MONA OFFSHORE WIND PROJECT

Change Request Consultation Feedback Response

Document Reference: S_D6_2

20 December 2024

Figure 1: Existing Access Junction Location

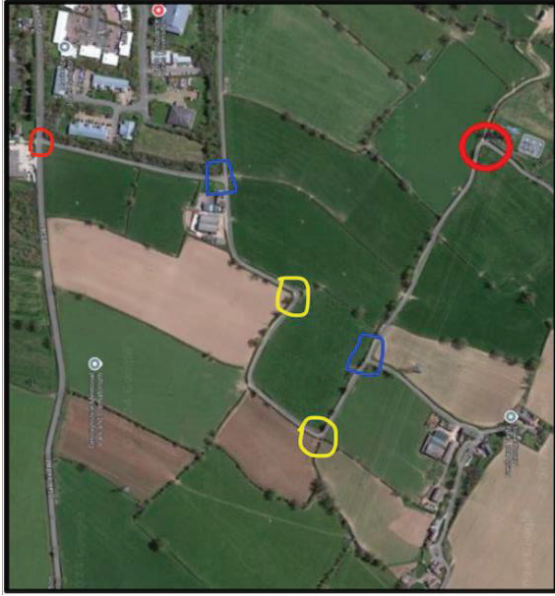
<p>B-7.16</p>	<p>15. Bends. As shown using the Applicant's own illustration (Figure 1 in the Appendix, with additions as explained herein), the road runs for approximately 1.25 kms from its junction with B5381 Glascoed Road to the changed access AC-T1 requested by the Applicant (red circles). The initial approximately 0.25 kms and final approximately 0.35 kms are straight or relatively straight and without junctions. However the intervening approximately 0.65 kms (blue markers) contains four ninetydegree bends and two</p>	<p>The Applicant notes the response and refers to Appendix 1 to Annex 1 of the Change Request Report (CR1-030) which provides an assessment of the road in terms of its geometries, layout, passing locations, vehicle movements and road safety and did not identify any current road safety issues along the road or at its junction with the B5381.</p>

additional sharp bends, only one of which, at the first blue marker, has any form of visibility splay. All the rest are bounded by hedges, with in some cases high banks.

The Applicant has updated the Outline Construction Traffic Management Plan (J26.13 F04) to include additional measures to ensure the safe use of the B5381 to Access AC-T1 (Change Request 1a). These updates have been agreed as suitable by the relevant local highway authority (CR1-046).
